# SAN FRANCISCO PLANNING DEPARTMENT

## Discretionary Review Abbreviated Analysis HEARING DATE: MARCH 14, 2019

*Date:* February 28, 2019  
*Case No.:* **2016-006123DRP-02**  
*Project Addresses:* **279 Bella Vista Way**  
*Permit Applications:* 2016.0421.5348  
*Zoning:* RH-1[Residential House, Single-Family]  
40-X Height and Bulk District  
*Area Plan:* N/A  
*Block/Lot:* 2998/021  
*Project Sponsor:* Matt Hollis  
Matt Hollis Architects  
2325 Third St. suite 224  
San Francisco, CA 94107  
*Staff Contact:* David Winslow – (415) 575-9159  
[David.Winslow@sfgov.org](mailto:David.Winslow@sfgov.org)  
*Recommendation:* **Take DR and Approve with modifications**

The project consists of construction of a 228 s.f. horizontal rear addition at the ground level, and a 591 s.f. horizontal rear addition at the second floor of an existing 2-story, single-family dwelling.

Photo 4

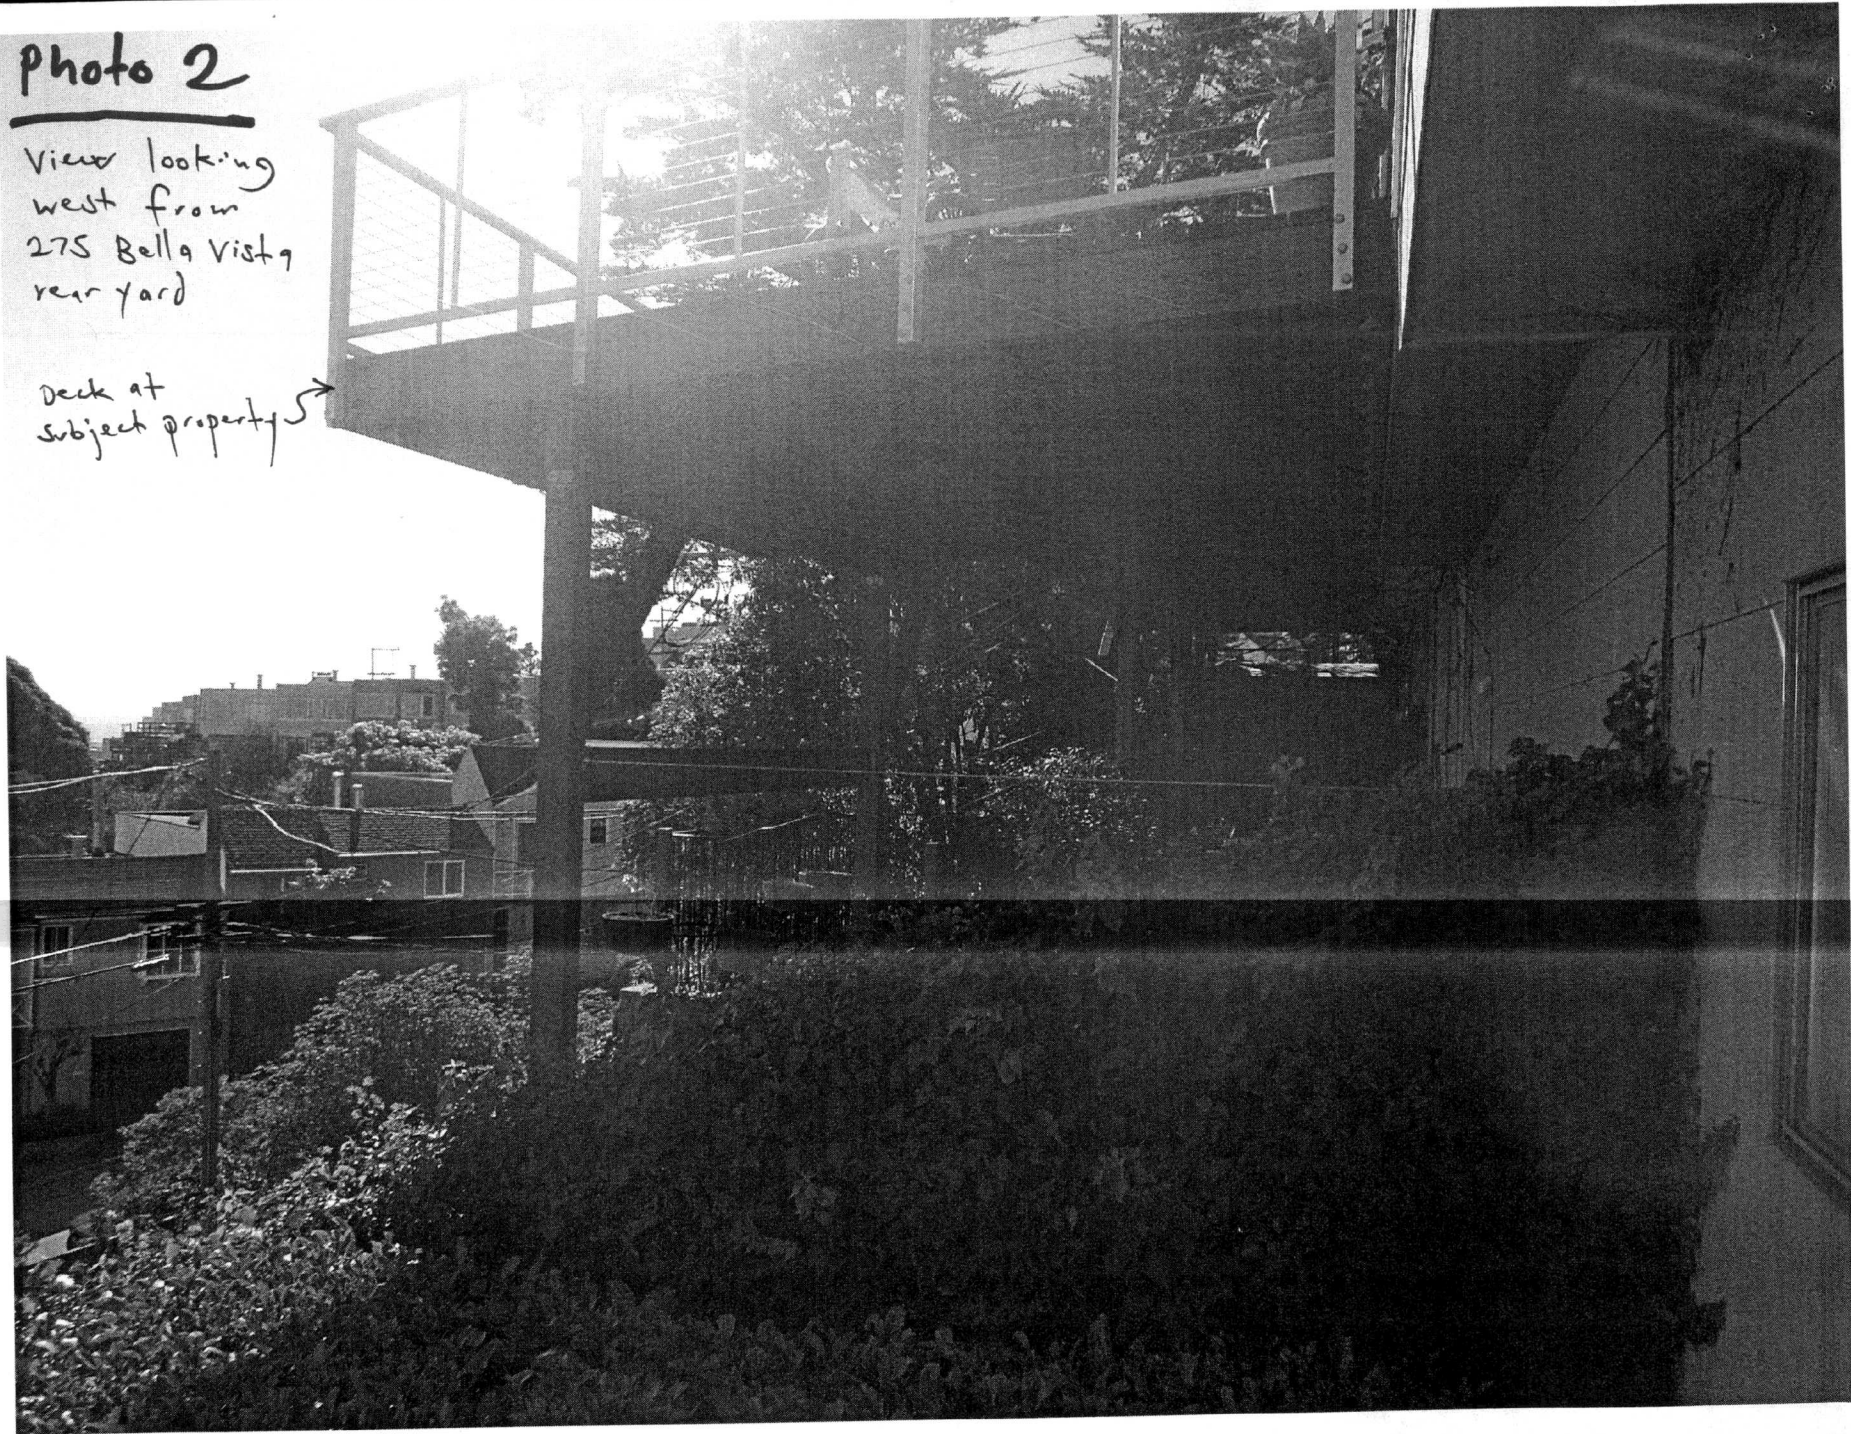
5. Page 26 of the SFRDG notes how side setbacks at additions can lessen the sense of being "boxed-in" for surrounding residents. I ask that the side of the top floor addition be set in 3' near the rear walls of my top floor and 5' at the rear-most portion of the addition to provide a greater sense of openness for me. Minimizing the impact of rear additions on adjacent buildings is noted on page 30 of the MPRDG. See Photos 1, 4 and 5 for the existing open roofs.

5. Page 26 of the SFRDG notes how side setbacks at additions can lessen the sense of being "boxed-in" for surrounding residents. I ask that the sides of the top floor addition be set in 3' near the rear walls of my top floor and 5' at the rear-most portion of the addition to provide a greater sense of openness for me. Minimizing the impact of rear additions on adjacent buildings is noted on page 30 of the MPRDG. See Photos 1, 4 and 5 for the existing open roofs.

2 Proposed First Floor  
Scale: 1/4" = 1'-0"

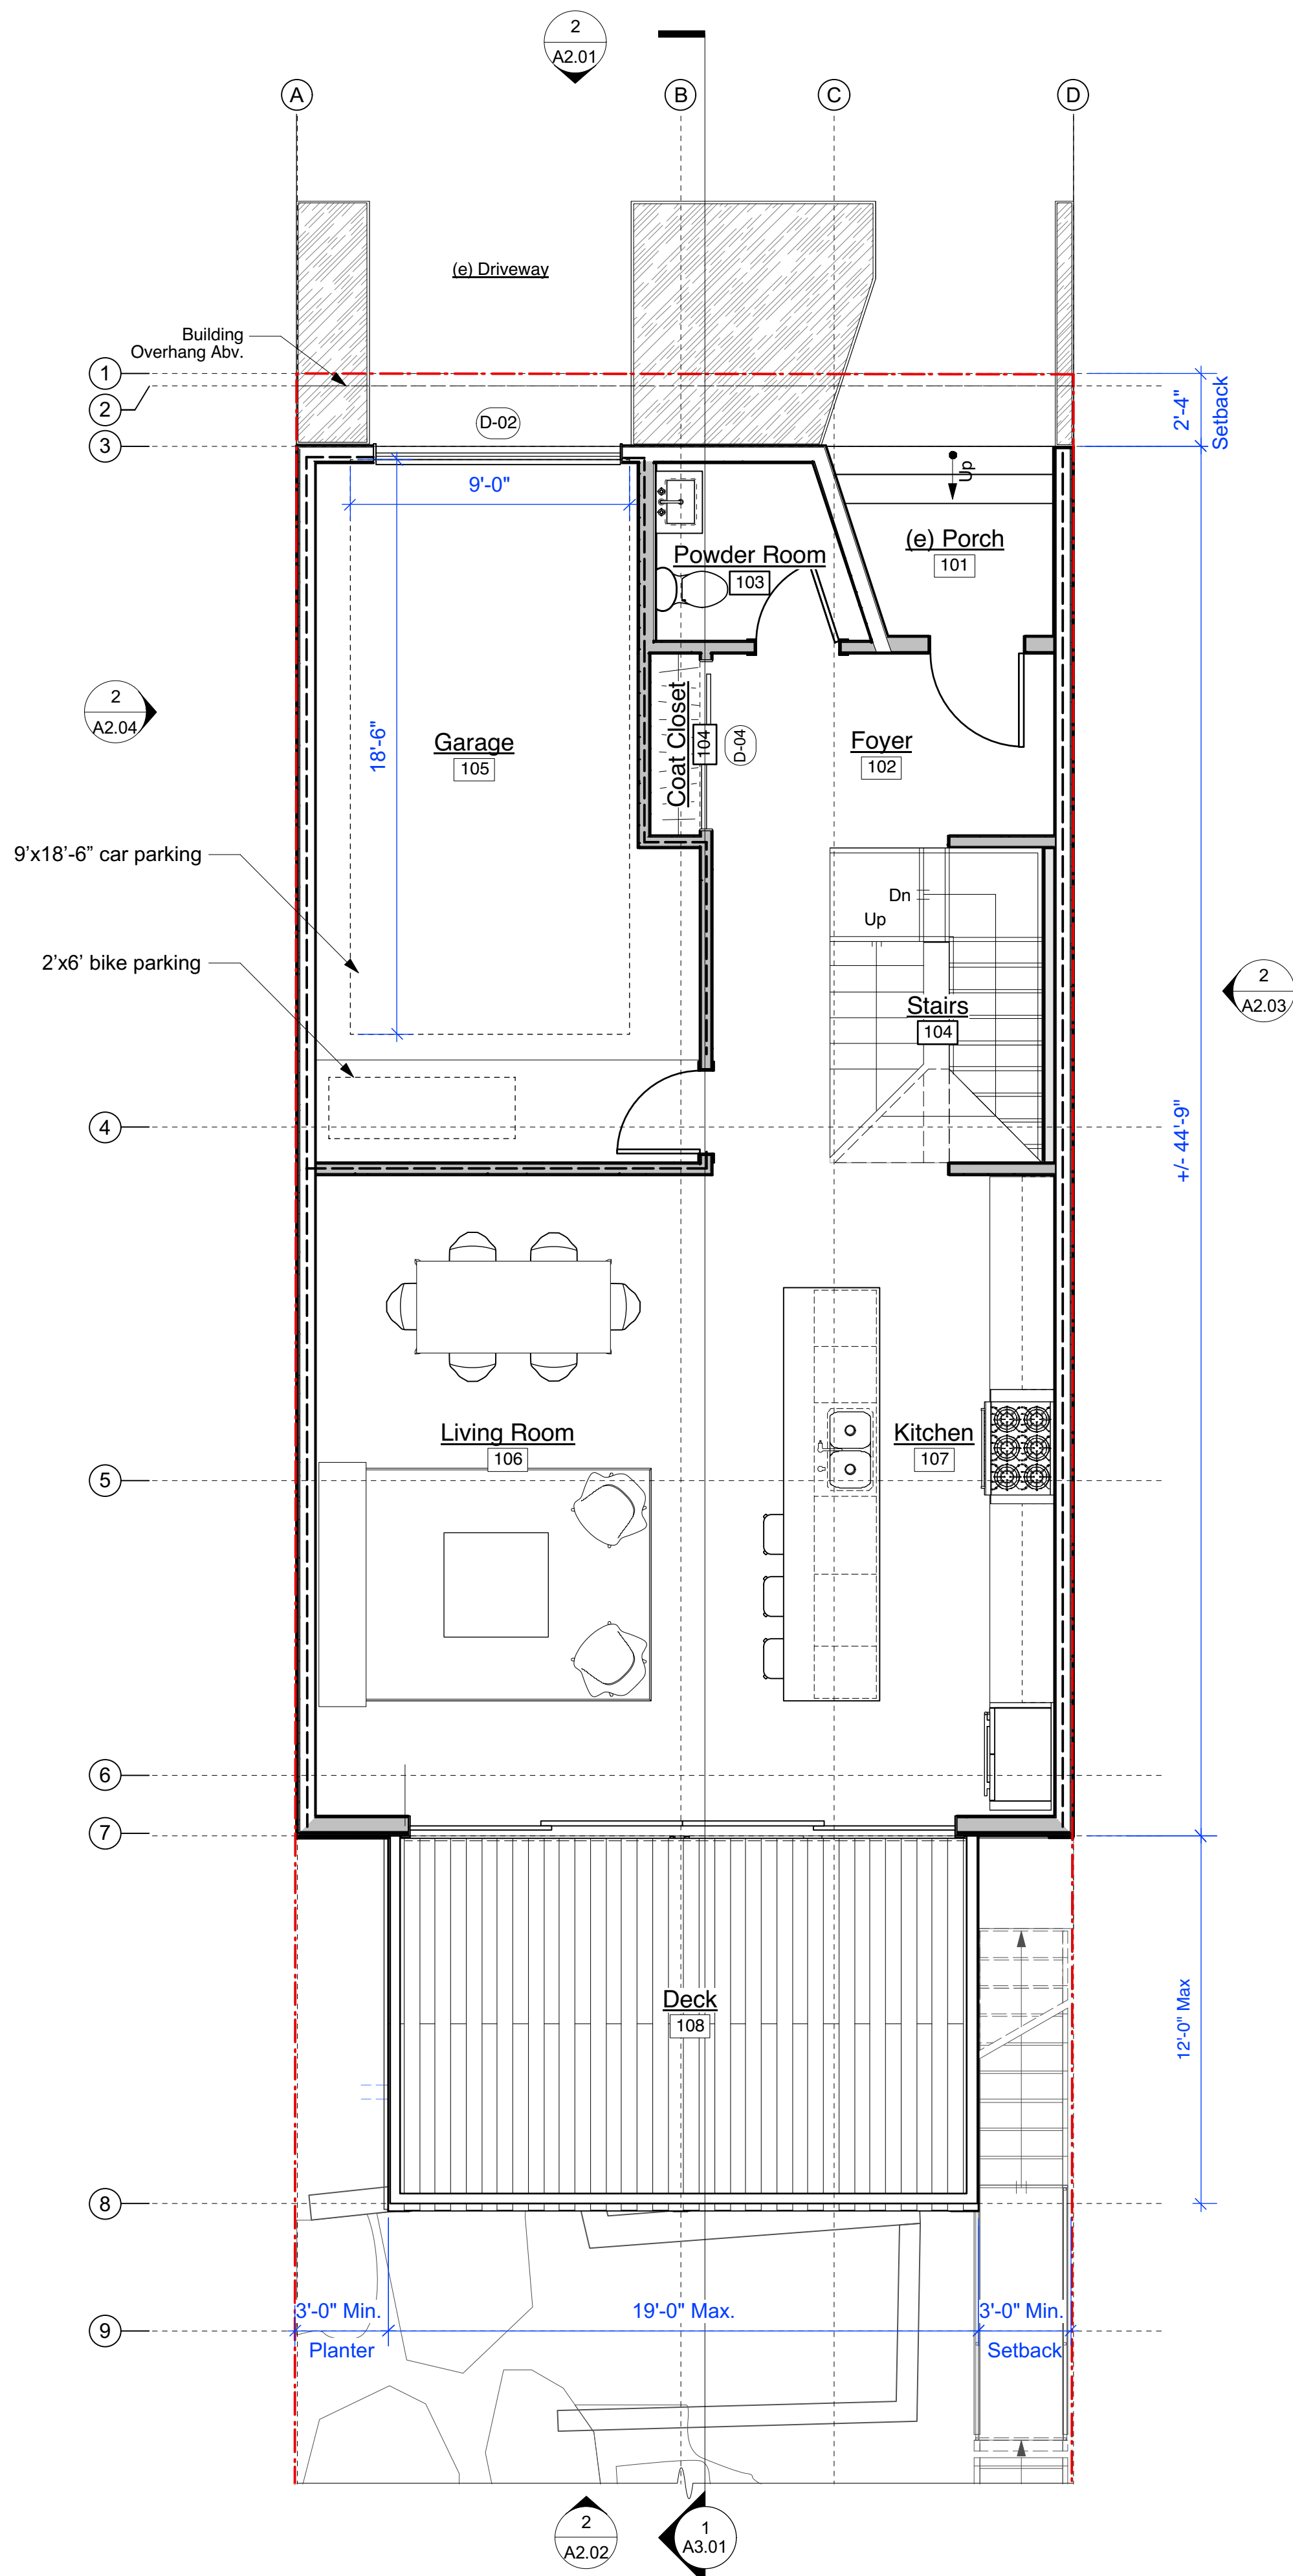
2. The elevation drawings on sheets A2.03 and A2.04 are mislabeled in terms of the directions they face and the proposed deck on the Proposed First Floor Plan on sheet A1.02, Deck #1, isn't labeled. Also, I don't see the profile of our houses on the elevation drawings. Finally, the elevations don't note the proposed finish materials on the sides of the addition. Therefore, I ask that the drawings be revised to provide this legibility.

2. The elevation drawings on sheets A2.03 and A2.04 are mislabeled in terms of the directions they face and the proposed deck on the Proposed First Floor Plan on sheet A1.02, Deck #1, isn't labeled. Also, I don't see the profile of my house on the elevation drawings. Finally, the elevations don't note the proposed finish materials on the sides of the addition. Therefore, I ask that the drawings be revised to provide this legibility.
